**INFORMAL REFERRAL COMMENTS – DA 090/M021/20  
REVISED PROPOSAL 17 FEBRUARY 2022 - 70 GREENHILL ROAD WAYVILLE**

*Construction of a multi-storey, mixed use building comprising residential and commercial uses together with carparking and site works.*

**INFORMAL REFERRAL COMMENTS – DA 090/M021/20 – REVISED PROPOSAL  
70 GREENHILL ROAD WAYVILLE**

**INFORMAL REFERRAL COMMENTS – DA 090/M021/20  
70 GREENHILL ROAD WAYVILLE**

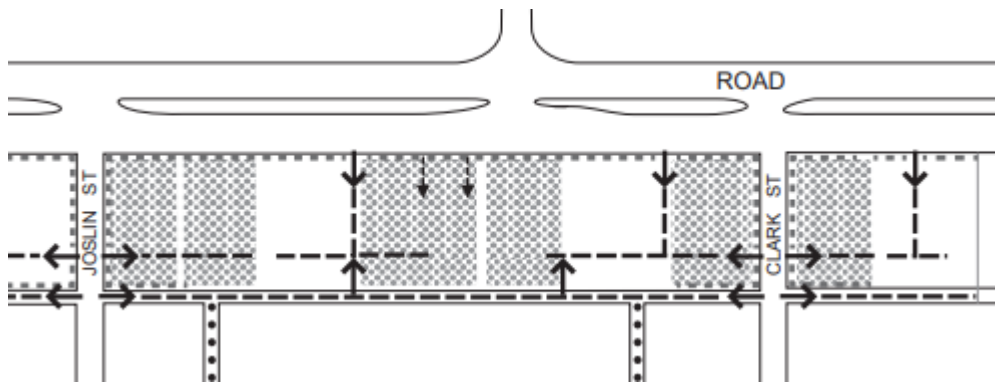
Vehicle access is entirely from Greenhill Lane (6.1 metres wide) and via two two-way crossovers (comprising 12.2 of 18.1 metres frontage). This replaces the existing single two-way crossover to Greenhill Lane.

Greenhill Lane is a two-way lane currently providing access to 10 car parks on the northern side, only one of which has a dual access from Greenhill Road. It also provides rear access to residential properties on the southern side. Traffic counts undertaken in 2018 indicate that Greenhill Lane carries approximately 450 vehicles per day. However, as this data is generally collected approximately half way between Joslin Street and Clark Street, it does not capture traffic entering and exiting from the same street (for example, entering from Clark Street and accessing a car park to properties 64-70 Greenhill Road, and exiting to Clark Street). This suggests that the traffic volume is likely significantly higher.

Estimated traffic generation rates in Department of Infrastructure and Transport (DIT) '*Trip generation rates for assessment of development proposals (2014)*' indicates that the development would generate 220 vehicle trips per day and 23 in the peak hour (assuming medium density and larger dwellings, which is appropriate considering the high proportion of 3-bedroom apartments). This would be significantly higher if the ground floor tenancy were a shop like a supermarket, eg an IGA, instead of an office, as mentioned in the planning report. This would result in a theoretical total trip generation of 648 vehicles per day and 65 during the peak hour for the development. However, this would be unlikely fully realised as parking supply would limit the number of potential customers.

The lack of a larger site (encouraged amalgamation) and distribution of consolidated access points and distributed movements to Greenhill Road per Concept Plan Un/6 compromises envisaged, proper and orderly long-term development outcomes and traffic management. All traffic (anticipated 220 vehicles per day) to Greenhill Lane will compound existing load, and with further such envisaged development, will inevitably lead to excessive pressure, conflict and dis-function of Greenhill Lane.
